Service Advisory

W-117

Model: GT-2550 14AZ816P190

Subject: DECK HANGER FOR 50-INCH DECK

Figure 1

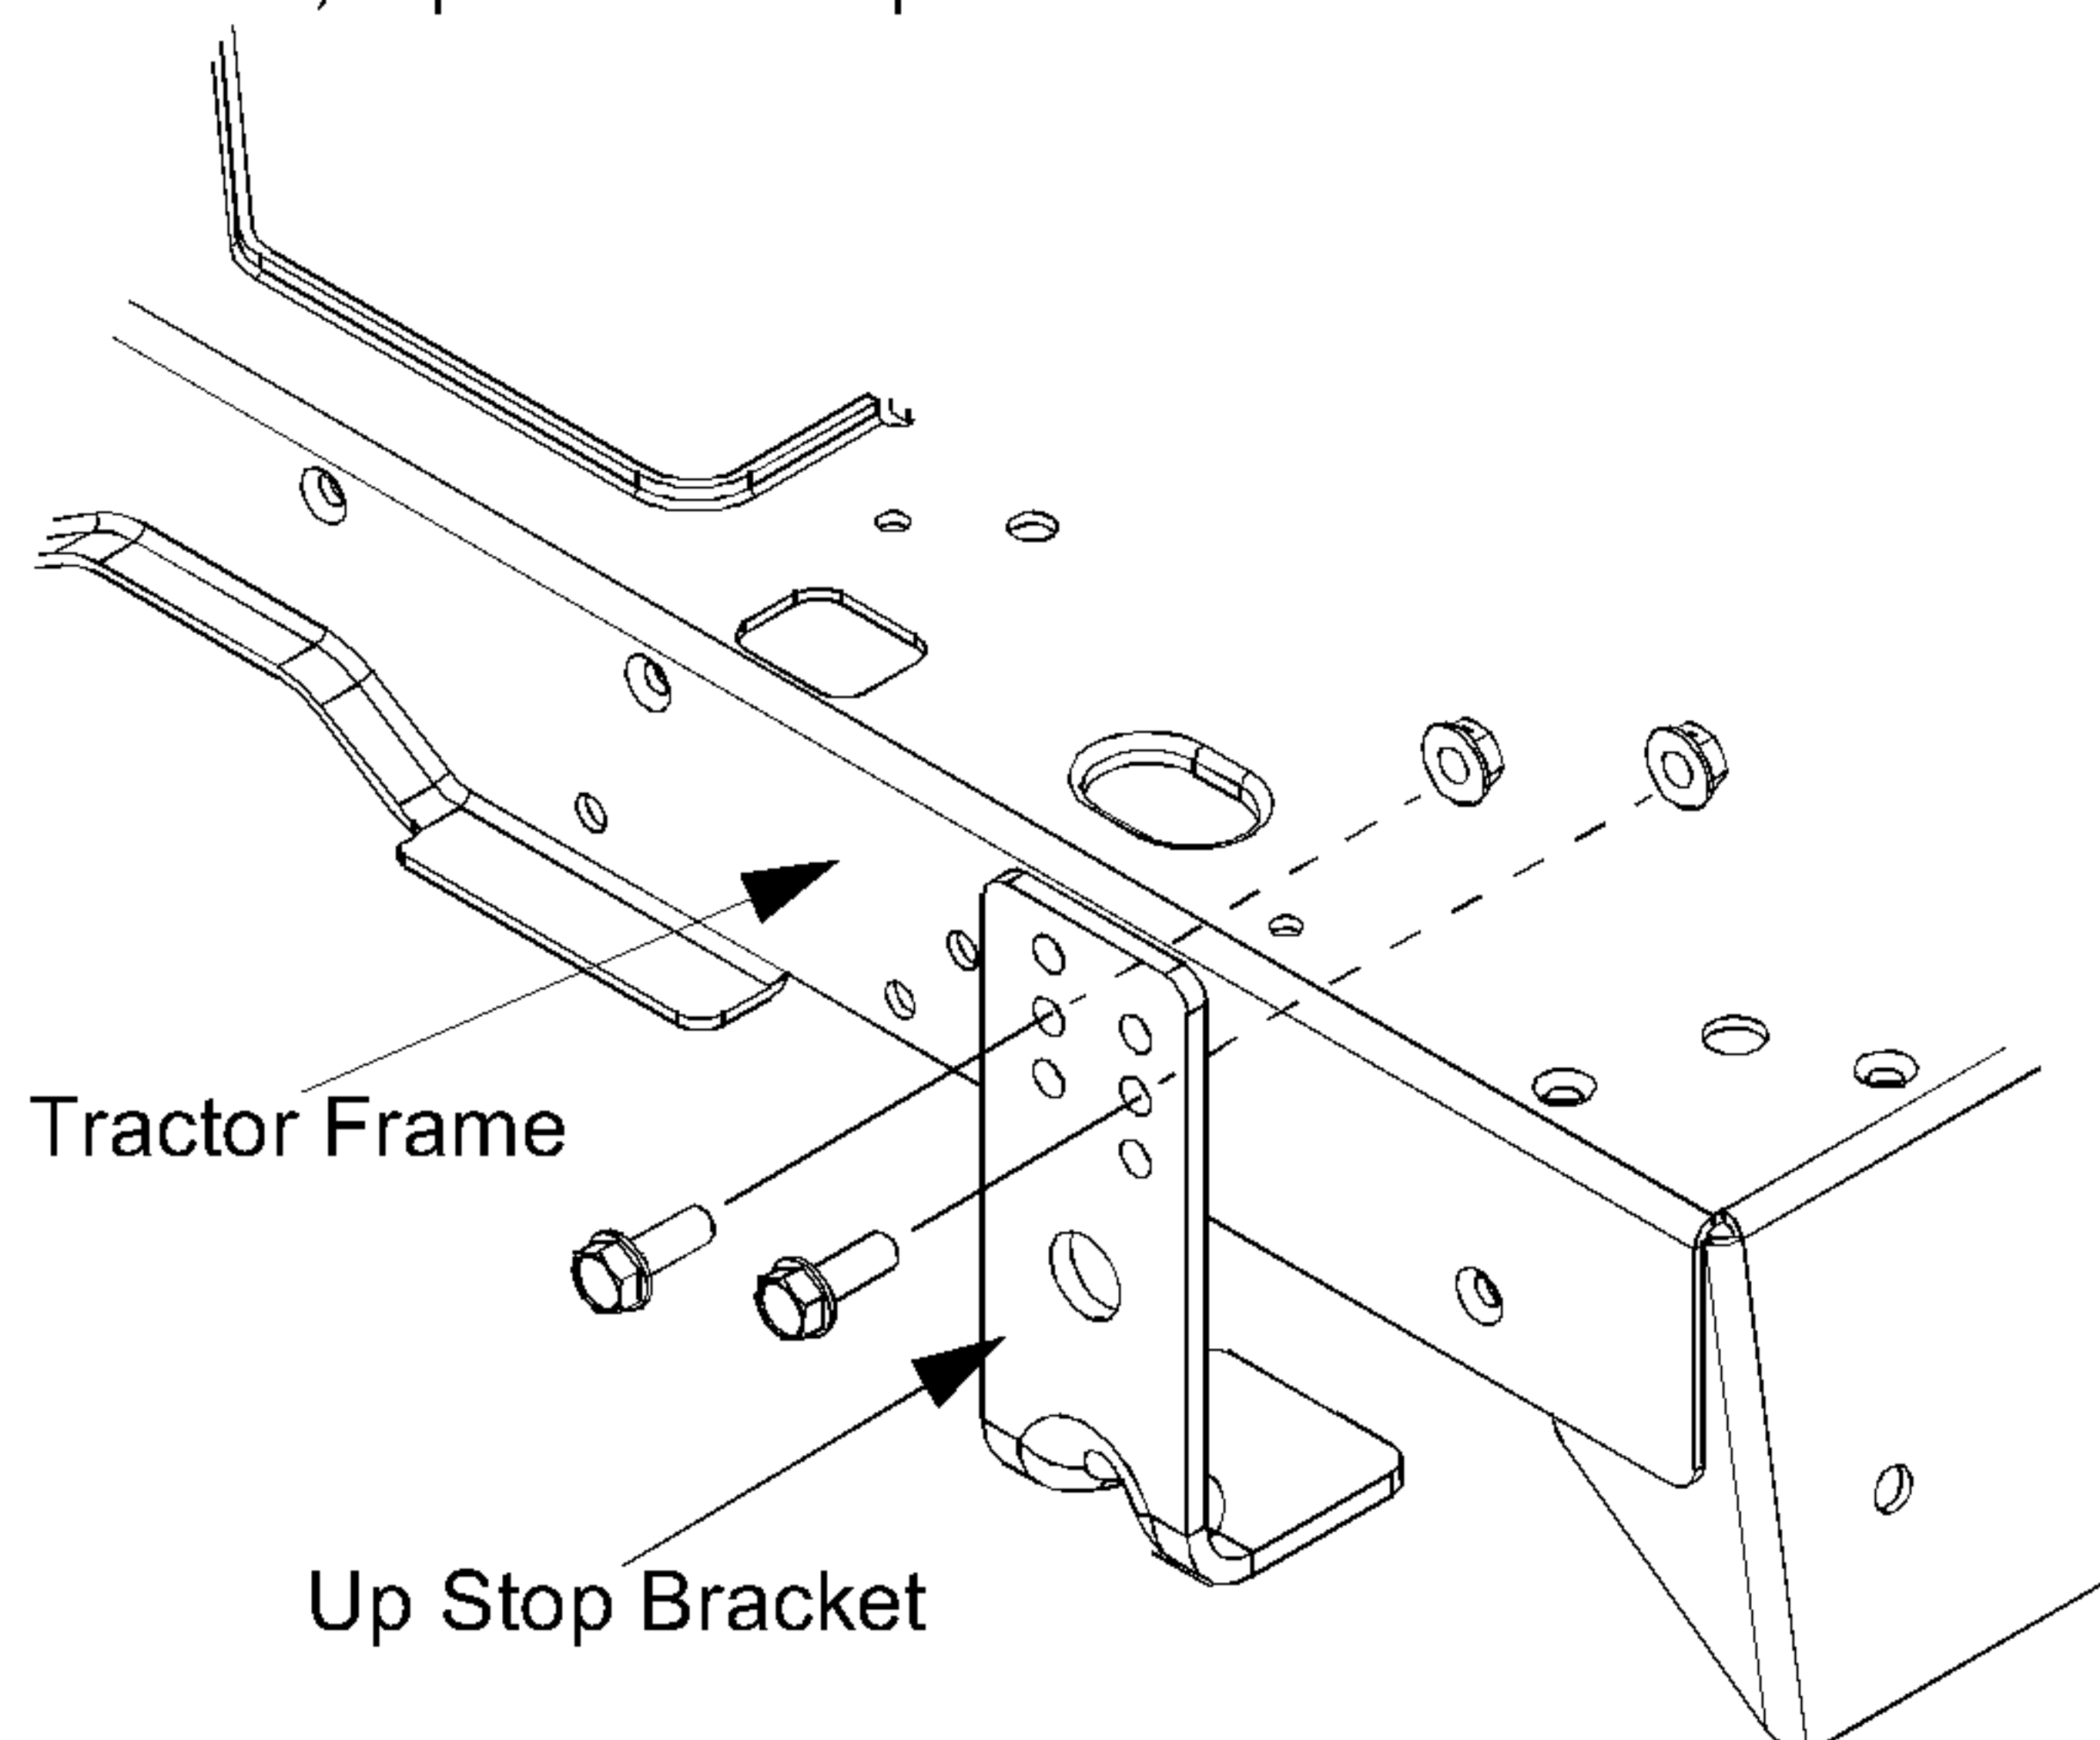
1. Locate the **up stop bracket** on the right side of the **tractor frame** in front of the deck. See Figure 1.
2. Make sure it is mounted using the center set of holes as shown. See Figure 1.
3. If the bracket on your tractor does not have three sets of holes, replace it with part number 783-0891B.

Figure 2

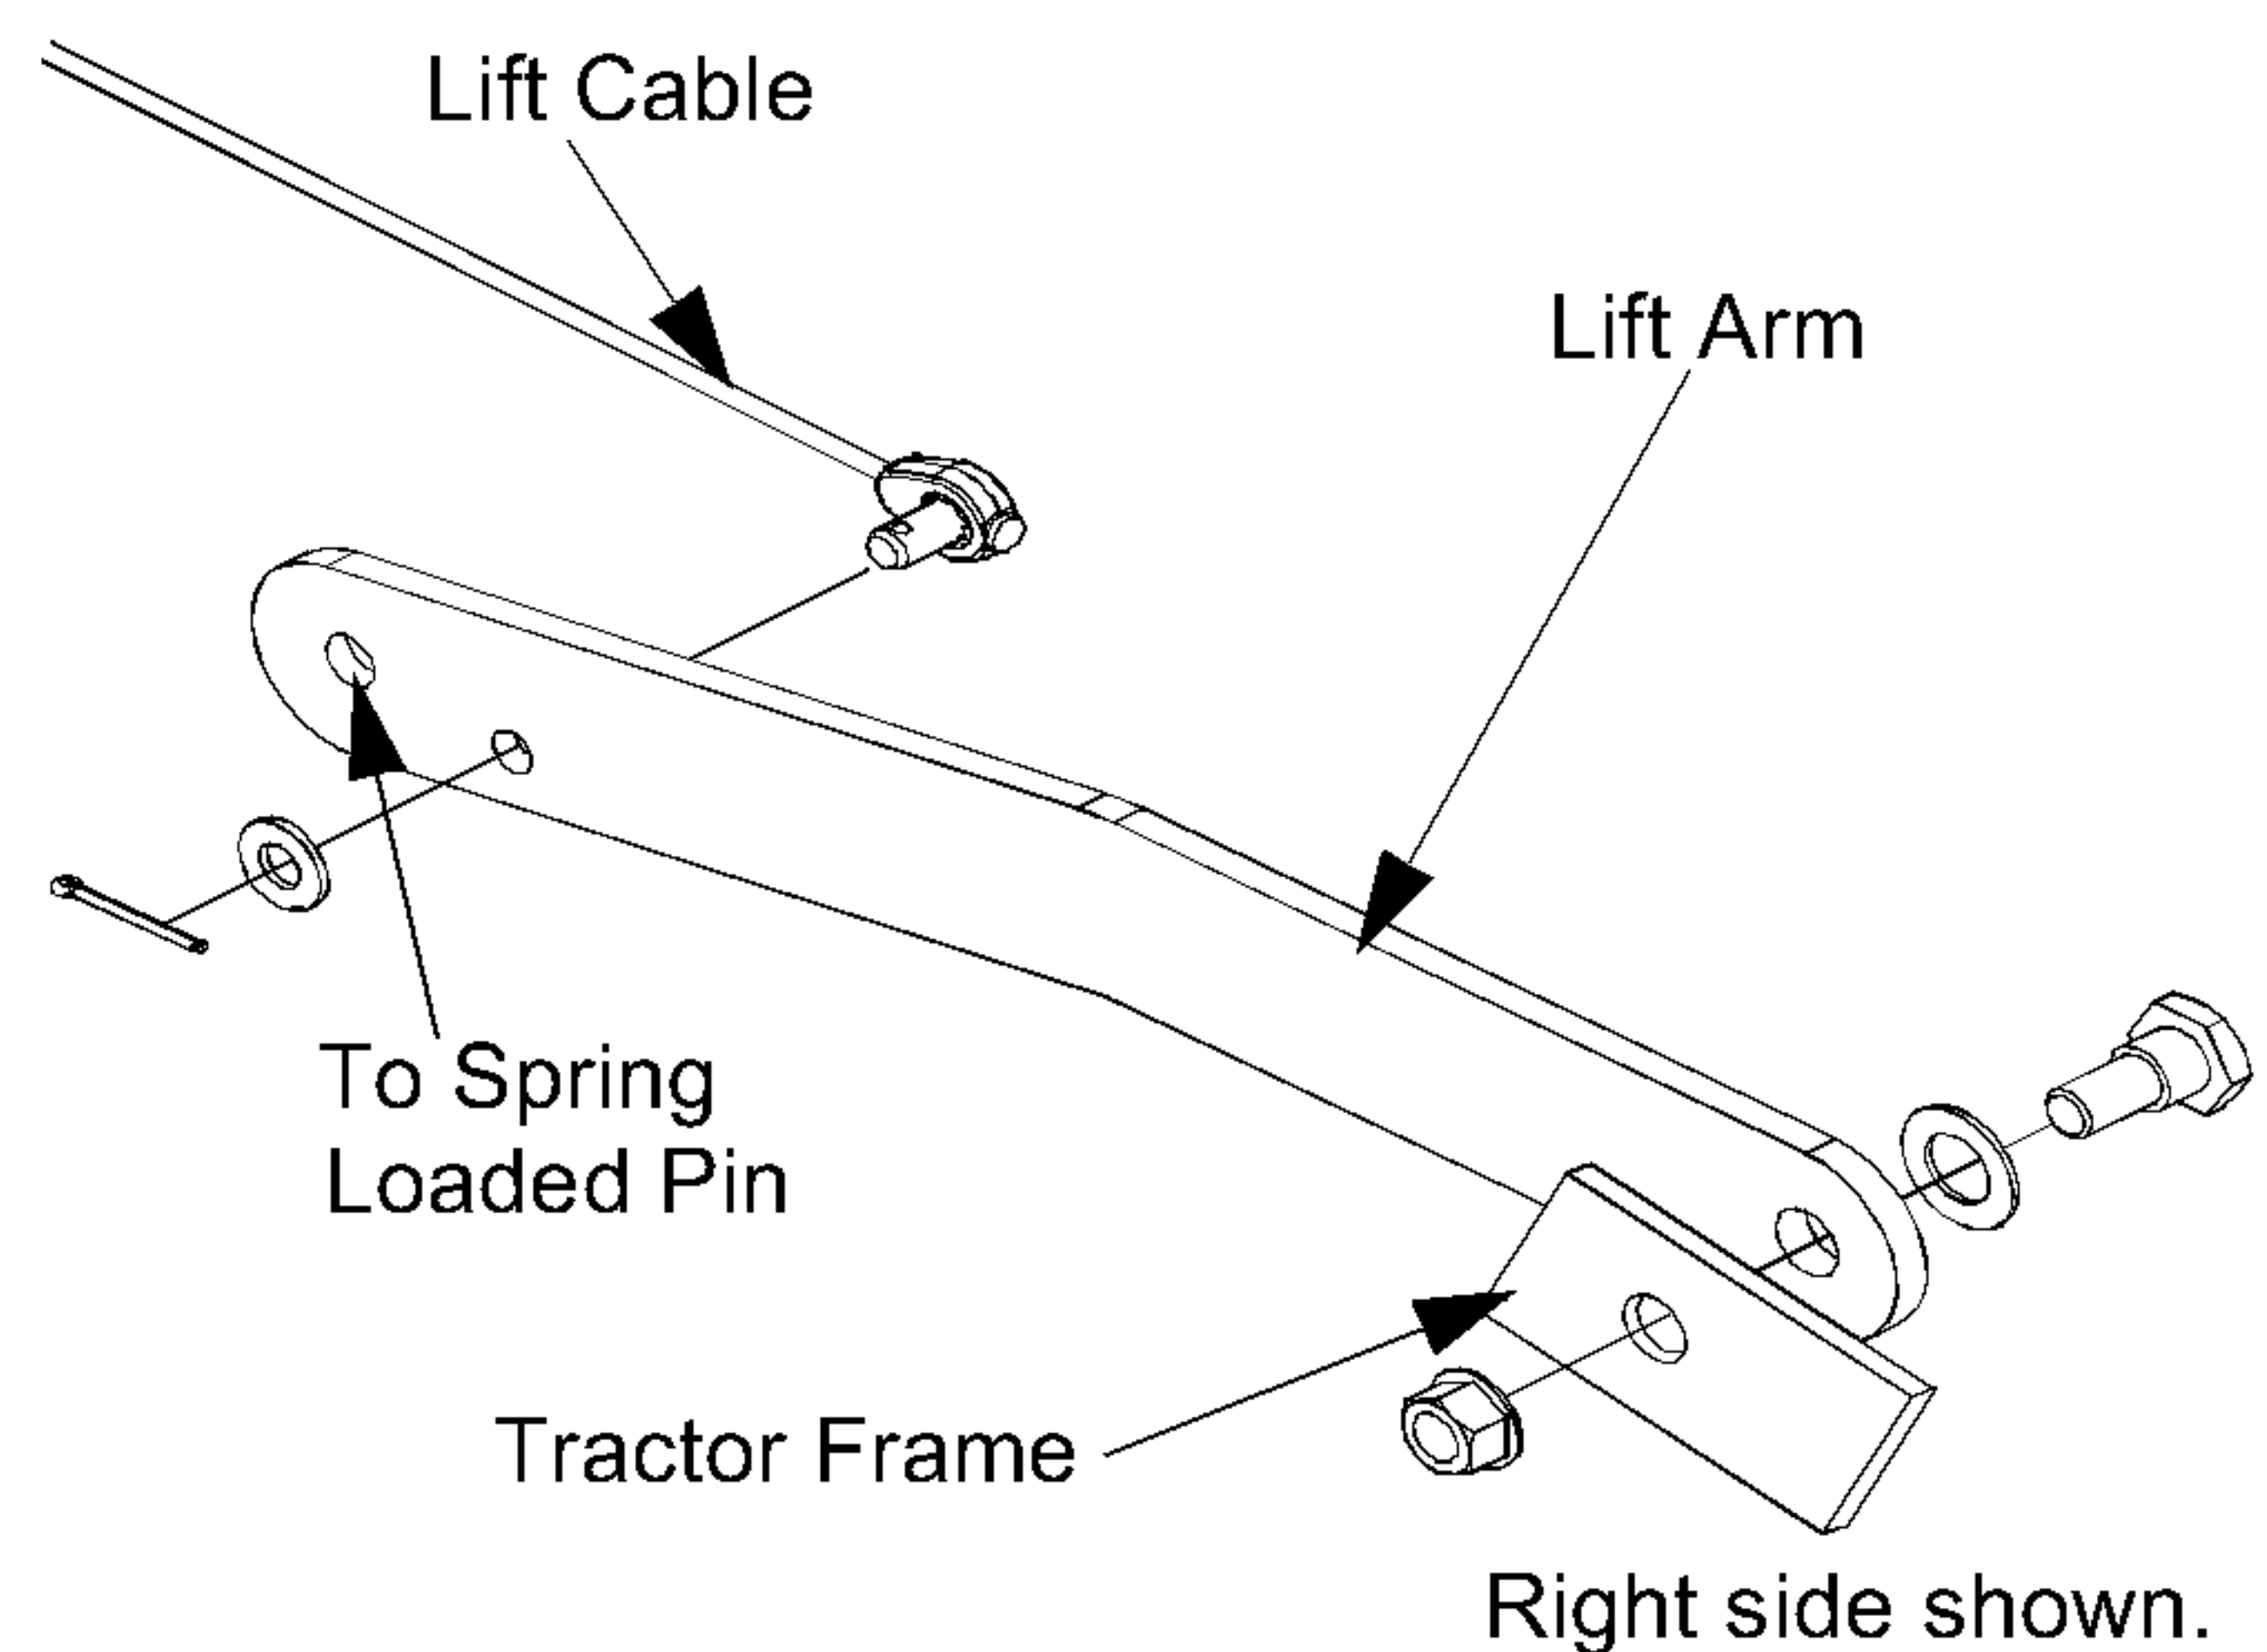
1. Remove the **lift arms** from both sides of the tractor by disconnecting them from the spring loaded pins at the rear of the deck, the **lift cables**, and the **tractor frame**. See Figure 2.
